DETERMINATION OF NON-SIGNIFICANCE

FILE NUMBER: 06-133380-LD

**City of Bellevue
Department of Planning and Community Development
Development Services Division Staff Report**

Proposal Name: Bel-Red Office Building
Proposal Address: 15063 Bel-Red Road
Proposal Description: Construct a 19,871 square foot three-story office building with 73 surface parking stalls, site landscaping and associated utilities.
File Number: 06-133380-LD
Applicant: Mark Alguard, Kirkland Builders Group
Decisions Included: Design Review with SEPA - Process II (LUC 20.30F)
Planner: Carol Saari *Saari*
State Environmental Policy Act
Threshold Determination: **Determination of Non-Significance (DNS)**

2 NORTH ELEVATION
1/8" = 1'-0"

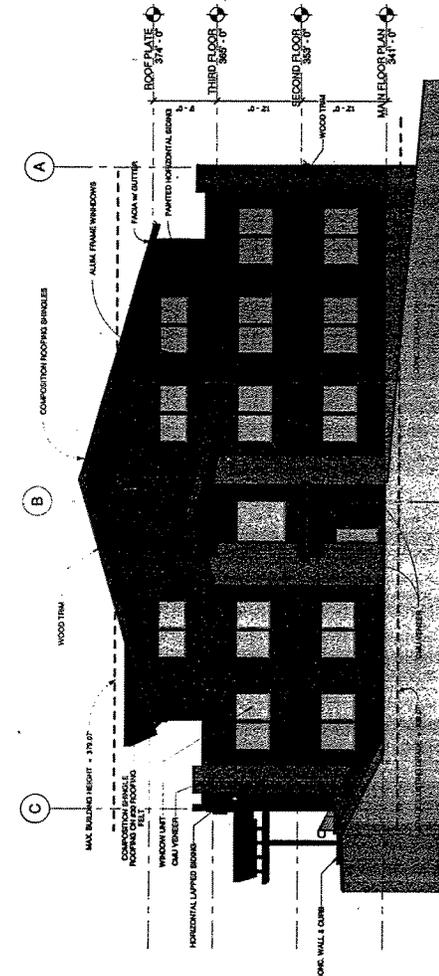
The applicant has chosen to use two bonus elements, a pitched roof and no mechanical equipment on the roof, to increase the height of the structure from 30 feet to 40 feet. The proposed structure appears to be slightly over the 40-foot height limit to the mid-point of a pitched roof. The applicant will need to clarify Sheet A-1, Detail 2, which portrays a roof mid-point slightly above the 40' height maximum. A height survey will be required prior to pouring the foundation and prior to calling for the framing inspection. See conditions #X.C.1, D.5.

The applicant shall clarify Sheet A-1, Detail 2, which portrays a roof mid-point slightly above the 40' height maximum allowed. If above 40', the roof shall be lowered to meet this requirement. The applicant shall provide elevation drawings (all sides) which show the mid-point of the pitched roof, maximum building height (per code) and proposed building height to the mid-point of the pitched roof.
